RE: Response to Comments, Bennoc Area NPDES OIL00159 Application for American Energy Corporation in Belmont County, Ohio

Response to OEPA Comments from Bruce Goff and Eric Nygaard Dated 8/21/12, 8/15/12, 7/20/12, 7/13/12, and 7/11/12 Bennoc NPDES Permit Application OIL00159

Wheel treatment system – pictures provided by www.chemstream.com

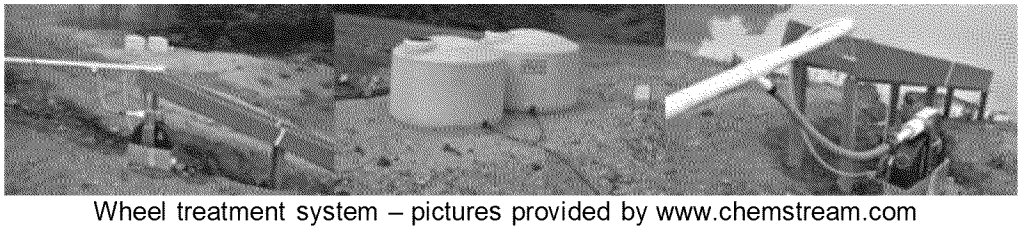
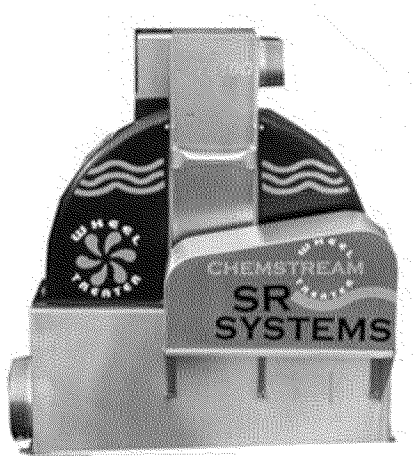
Comment: Do you happen to have any photos of the treatment ponds, the outlet structures, the chemical feed equipment and the discharge drainage ways (outlet ditches) you can share?

Response: We do not have any pictures of the proposed treatment ponds and their structures. However, we do have a picture (below) of the proposed wheel treatment system.

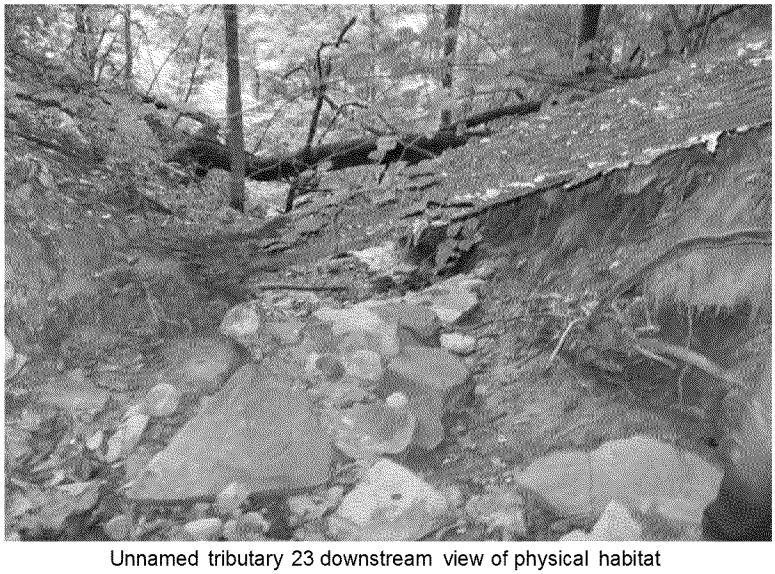
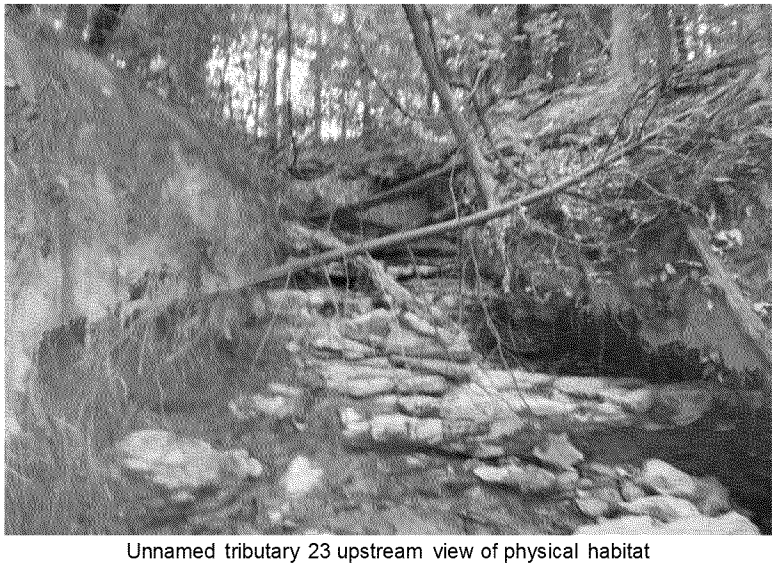
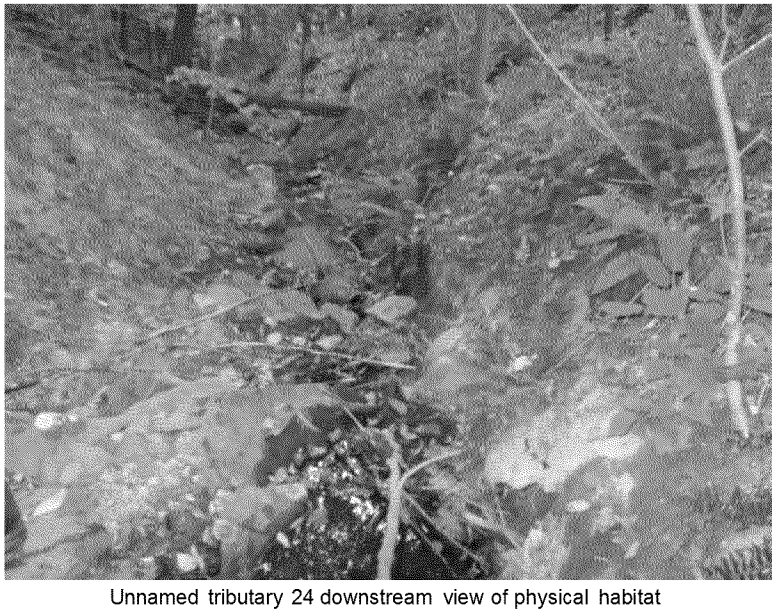
Comment: I don't know if would be on any use to us to help with permitting, but if you can have your biologists look at the two small tribs that both ponds discharge into and evaluate their potential for aquatic life use, that may be helpful.

Response: A field investigation was completed on July 13, 2012. The results of this investigation can be found in the attached report, "Investigation of Unnamed Receiving Tributaries to Piney Creek."
